30th May 2011

FS13 P84 0001

**Re: Submissions for Project Approval Modification Apex Energy
Additional Borehole AI19**

Figure 9 – AI19 and Associated Mine Workings

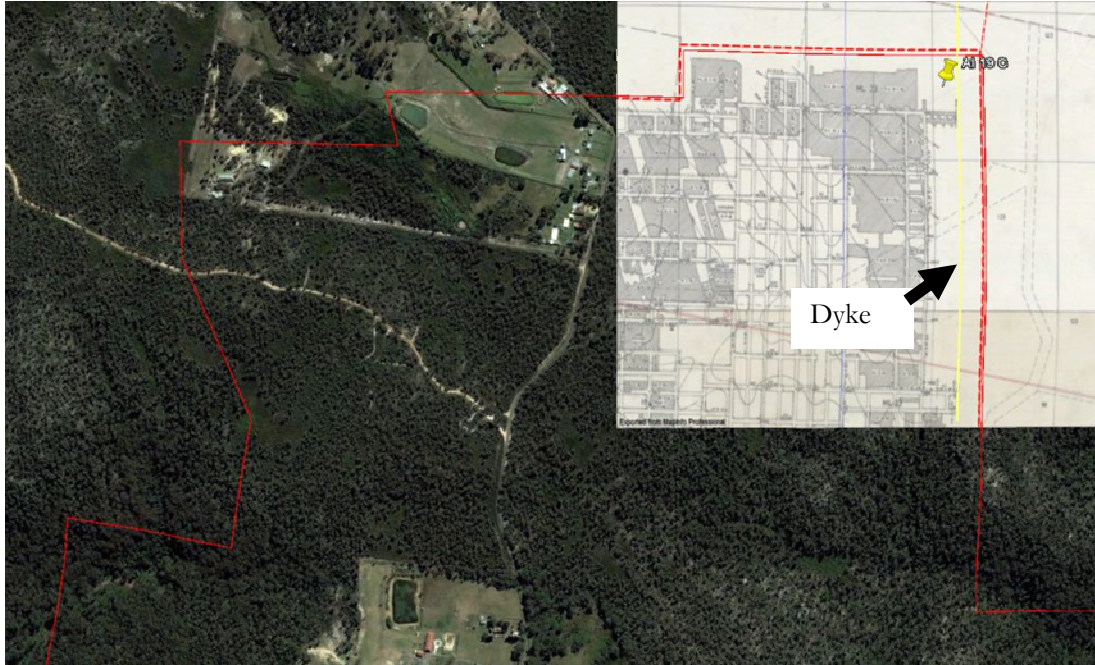
Submitter	Submission	Draft Response
	<p>As establishing the proposed borehole and site access will require primary vegetation disturbance and re-clearing along a closed fire road, the SCA would prefer the borehole not be located as proposed. The SCA has no operational reasons to re-open the fire road.</p> <p>The SCA is also aware that Apex has identified and evaluated an alternative strategy for obtaining their required information from a previously approved borehole (AI06)</p>	<p>The site and access track will be rehabilitated at the completion of activity in the area.</p> <p>It is incorrect to state that Apex has an alternative strategy for obtaining their required information from a previously approved borehole (AI06). Apex understands that the SCA view is based on an internal Apex report that identifies AI06 as a fall back option if AI19 is not approved.</p> <p>Apex already has approval for 15 exploration boreholes, including AI06. Borehole AI19 is subject to a current application (not yet approved) to modify the original project approval for the 15 boreholes. It is prudent planning on Apex's behalf to have alternatives should AI19 not be approved for proper and correct reasons. The document that SCA refers to does this. However, it clearly states that:</p> <ul style="list-style-type: none"> • AI19 is an ideal location. • AI06 will not give the same extent of resource definition as AI19. The coverage is reduced by approximately 28 square kilometres and potential reserves of 20 PJ. <p>AI06 is a possible contingency site only and is only relevant should AI19 not be approved for fair and valid reason. It is not an alternative for obtaining the best information.</p>

Submitter	Submission	Draft Response
<p>NSW Office of Water</p>	<p>The SCA then state that, “As borehole AI06 is located at a cleared site with appropriate access, the SCA recommends this modification application not be approved”.</p> <p>Provided comments with the following recommended conditions of approval that are additional to those already imposed by the original determination for the project.</p> <p>An authorisation under the <i>Water Act 1912</i> or the <i>Water Management Act 2000</i> is to be obtained from the NSW Office of Water with the appropriate purposes identified for any activity relating to the taking of or interception of groundwater prior to that activity commencing.</p> <p>Structures for the containment of drilling water and produced groundwater are to be either above ground or fully lined. Off-site disposal of these materials should be addressed in the Water Management Plan.</p> <p>Construction of all wells must be undertaken by a driller holding a water driller’s licence, valid in New South Wales.</p> <p>A groundwater quality and quantity monitoring plan is to be established and maintained which incorporates a monitoring schedule and adopted parameters to be monitored and agreed to by the NSW Office of Water.</p> <ul style="list-style-type: none"> • The monitoring program should establish appropriate sites for monitoring bores. • Monitoring bores should monitor discreet aquifers and not be open hole. All major aquifers should be monitored using data loggers, with emphasis on the aquifers where extraction occurs or the environment relies on groundwater (e.g. baseflow to rivers, Groundwater Dependent Ecosystems). • The monitoring program should include reporting of water level and quality in both the target and overlying aquifers. • The results of the monitoring are to be reported to the NSW Office of Water regularly, at a frequency consistent with the reporting arrangements required by other authorities or agencies to avoid duplication of effort where practical. 	<p>Apex will utilise the services of a licensed group to dispose of all drilling water and produced groundwater. Transpacific Industries Group Limited of Unanderra has been approached to provide these services. They have advised that water with less than 20% solids can be disposed at either Transpacific Waste Services facility in Homebush or at the LVRA facility in Appin. These facilities can receive up to 60 tonne and 20 tonne per day respectively. Material that contains greater than 20% solids can be taken to the Transpacific Technical Services facility in Newcastle.</p> <p>The mud pits and drill sumps would be constructed by excavation into the Hawkesbury Sandstone. These pits and the sump are on a small scale (totalling less than 100 cubic metres in volume) and are designed to enable accurate monitoring to identify if losses of recirculating water are occurring or inflows of water are being experienced. The Apex Groundwater Contingency Plan details how water levels in the mud pits and drill sump would be suitably monitored to detect small volume losses or gains. SCA, DECCW and NOW have never before required the lining of mud pits and sumps during drilling operations on the Woronora Plateau because it is commonly accepted that the transmissivity of the weathered Hawkesbury Sandstone was sufficiently low.</p> <p>Well construction will be undertaken by a driller holding a water driller’s licence, valid in New South Wales.</p> <p>The Soil and Water Management Plan details under what conditions monitoring of the both the quantity and quality of produced groundwater would be undertaken in this Exploration Program and has assessed the maximum degree of loss of drilling fluid to any aquifers encountered.</p> <p>The assertion that there are ‘coal seam aquifers’ in the</p>

Figure 9 shows AI19 in relation the boundary of PEL444 and the Darkes Forest Mine workings. Figure 10 shows a close up of AI19 and shows its location in relation to the known igneous intrusion (Dyke) and the mine workings. Therefore this site will enable the drilling operations to be conducted with reduced risk whilst fulfilling the requirements of Apex and MHA’s exploration philosophy.

Figure 1.
Location
 31 August 2010

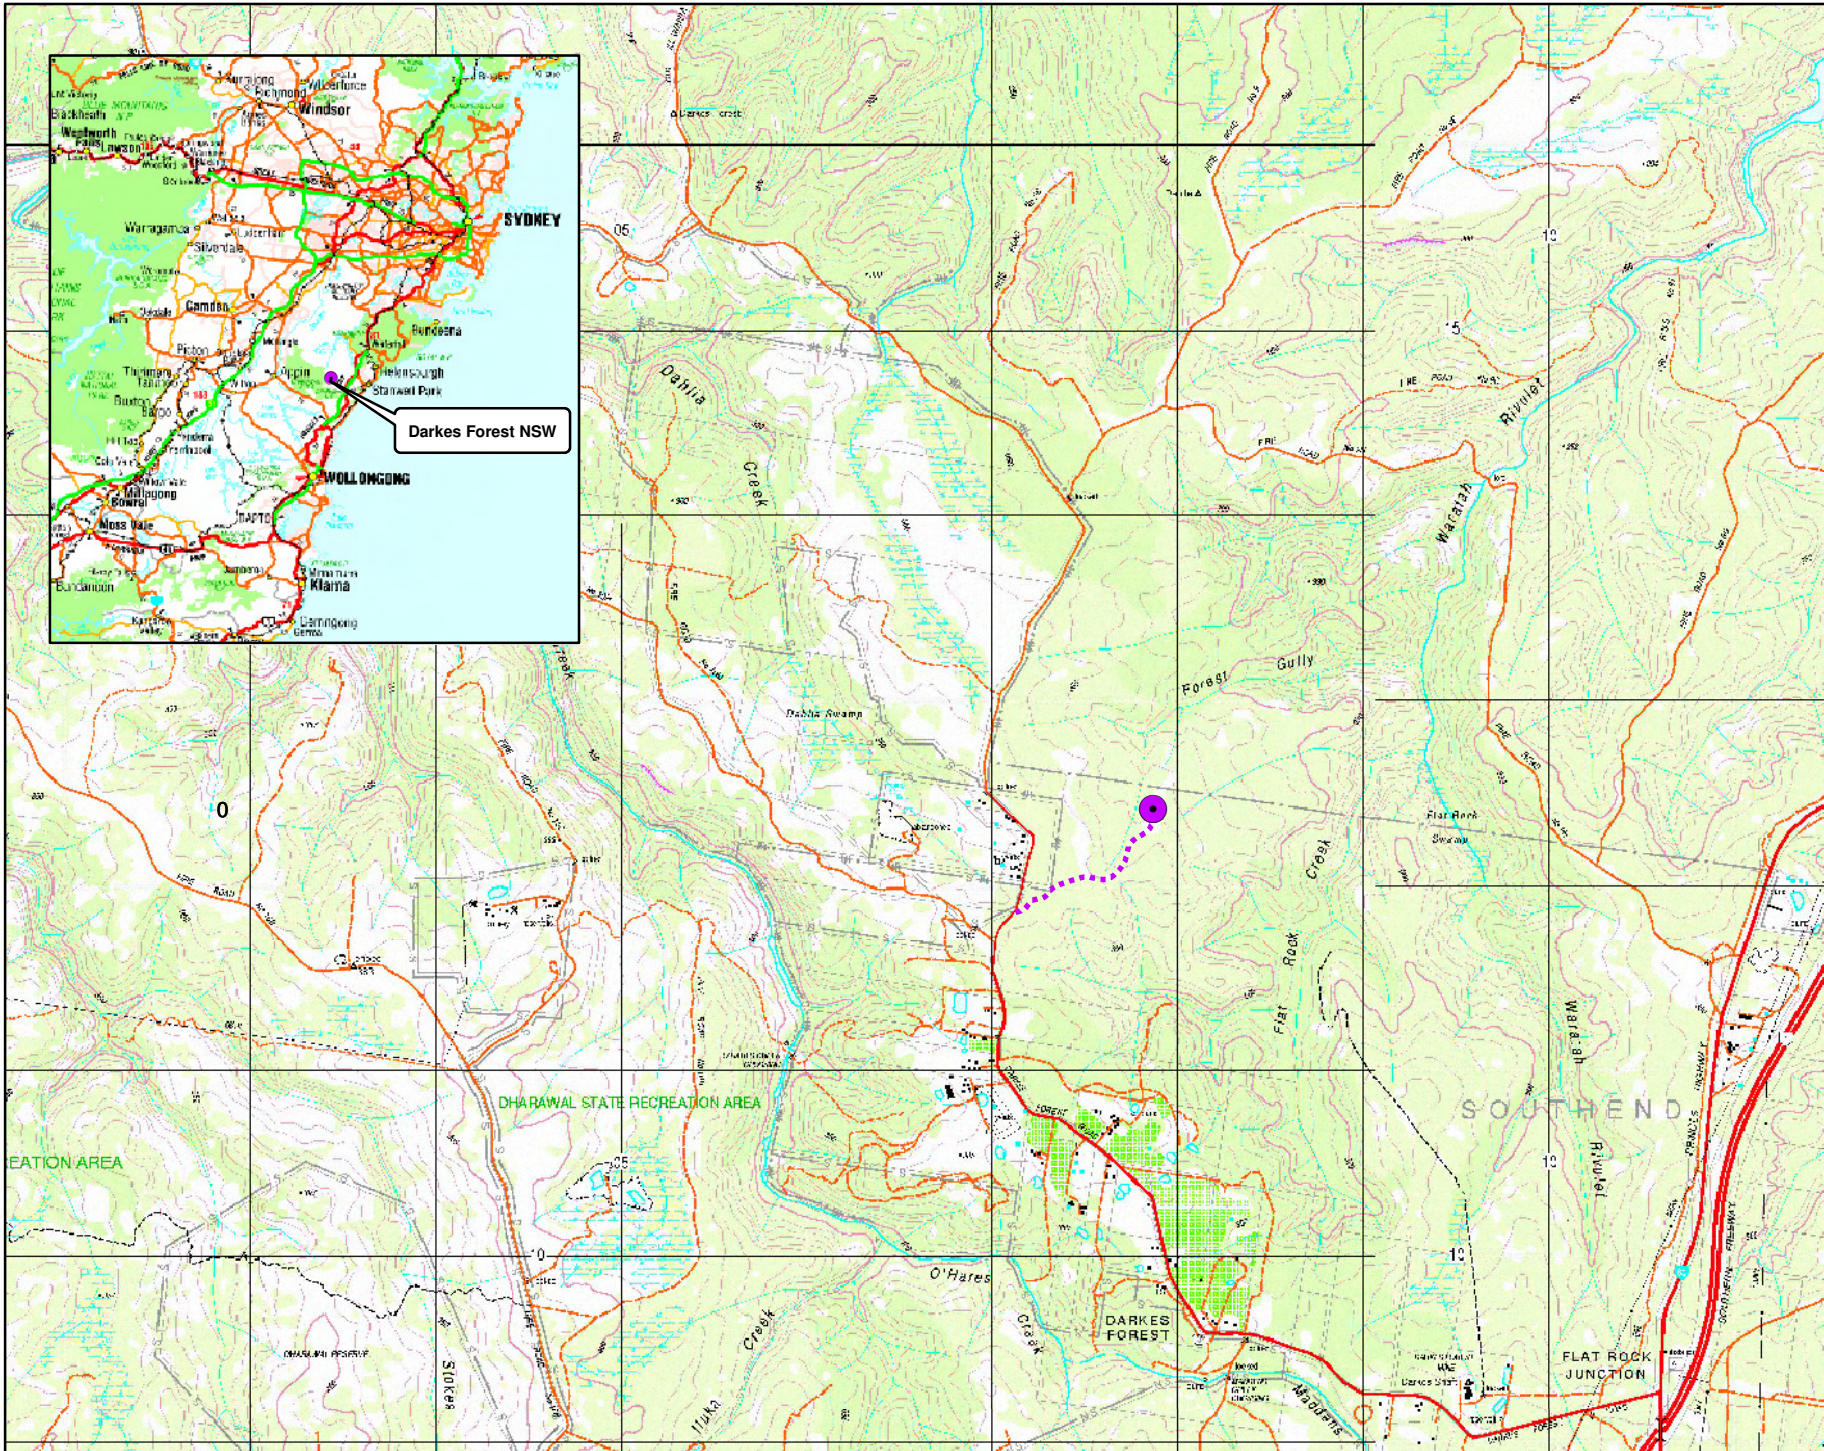
In a submission from DECCW to DoP dated 25 January 2011, DECCW noted that from a simple count of the data points identified as records of *Pultenaea aristata* from Figure 2 (green dots) of the 2010 Niche report a total of 100 individuals can be counted. Those individual records have been plotted on Figure 1 of this report. Further from the recent site visit for this report a further 140 (approx) individual records (apart from the records included in the 7 plots) were observed. A hand held GPS was used to record the distribution of the species along the access road and at the borehole site and within close proximity to these areas.

A total of 361 individuals of *Pultenaea aristata* were recorded from a total of seven 10m x 10m plots recorded in close proximity to the borehole site or the access track (see Figure 1). A total of 52 plants were located within the confines of the borehole site.

The value of this count then lies in assisting to delineate the possible boundary of the local population of the species. That is, from the interpretation of the air photo which has the plotted records of *P. aristata* an approximate boundary of the localised habitat for the species may be extrapolated as shown in Figure 1 based on the distribution of similar habitat types along and adjacent to the disused fire trail. The shaded area in Figure 1 is 3.96ha.

Figure 3
Pultenaea aristata
 within 10 km of the
 AI19 Borehole Site

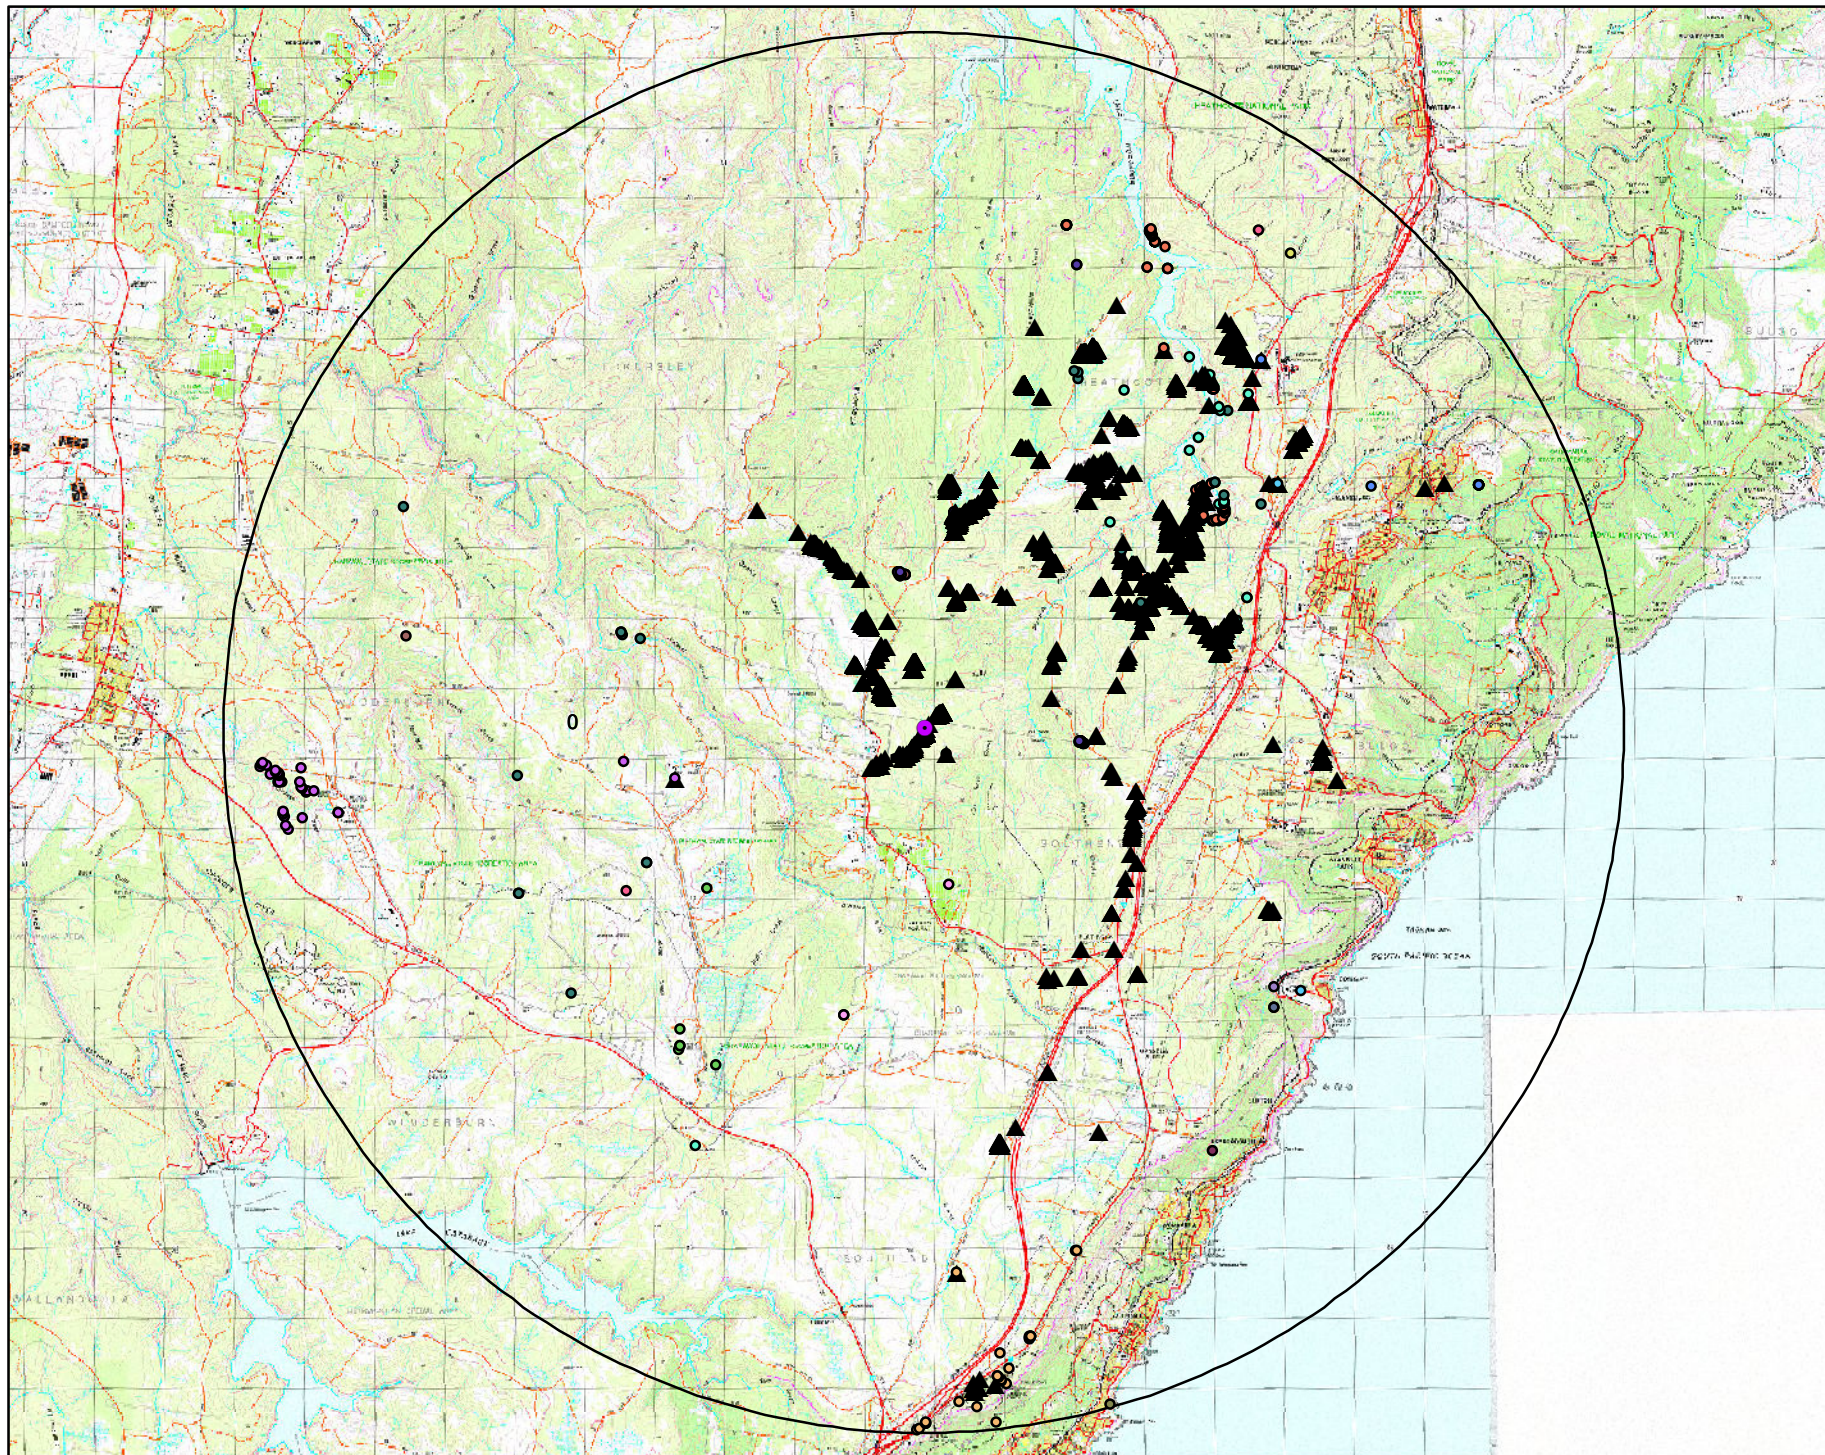
Submitter	Submission	Draft Response									
DECCW	Unable to support the proposal in its current form because the loss of approximately 100 Prickly Bush-pea individuals and 0.66ha of habitat is not considered to maintain or improve environmental outcomes for the species.	<p>There is a significant difference between what Niche identified and described at the site and the data that DECCW are relying on. The species is far more abundant than officially recognised. The large size of the populations of this species is readily attested to by people who work in the area from both mining companies and Government groups.</p> <p>Populations of <i>Pultenaea aristata</i> within the region are not uncommon and, in suitable habitat the species is often found to be a dominant shrub, in excess of thousands of individuals (pers. obs.). There are many known large populations of this plant species occurring within the O'Hare's Creek Catchment to the south west of the borehole site (pers. obs.) which are not included in the NSW Wildlife Atlas data illustrated on Figure 4 of Niche Environment and Heritage (2010), indicating that the NSW Wildlife Atlas does not include all known records in the local area. A search of some recent reports detailing survey work for <i>Pultenaea aristata</i> within the regional catchment areas illustrates the density of local populations of the species in the region:</p>

Table 2 outlines a population estimates and/or observations of very large populations of *P. aristata* in the region provided by qualified botanists. Figure 3 shows the distribution of known records of the species within a 10km radius of the site. It is noted that are many other known large populations of this plant species occurring within the O'Hare's Creek Catchment to the south west of the borehole site (Matthew Richardson pers. obs.) which are not included in the NSW Wildlife Atlas data. The NSW Wildlife Atlas does not include all known records in the local area of *P. aristata*.

Further, Figure 3 shows that there are a large number of *P. aristata* records. What the figure does not show is the age of the records or if each record represents an individual

plant or a population of individuals. It is therefore not possible to estimate the total regional population of the species from this data. However, it is known by the author that a significant number of records are not represented in the south-western portion of Figure 3 along the Appin road, both in Dharawal Nature Reserve and in the vicinity of the West Cliff Colliery (surveyed during the Species Impact Statement for the West Cliff Coal Wash Emplacement).

Secondly the majority of the records of the species plotted on Figure 3 are located on Fire Roads or other road networks. It is most probable that these records do not indicate a bias towards the species preferring disturbed easements as its ideal habitat although in the case of other threatened plant species (e.g. *Persoonia hirsuta* and *Acacia bynoeana* pers. obs.) this may be so. It is more likely that, as indicated by the distribution of known records, that the species is incidentally recorded along these easements as it is readily identifiable by the catchment and reserve managers frequenting these roads and tracks.
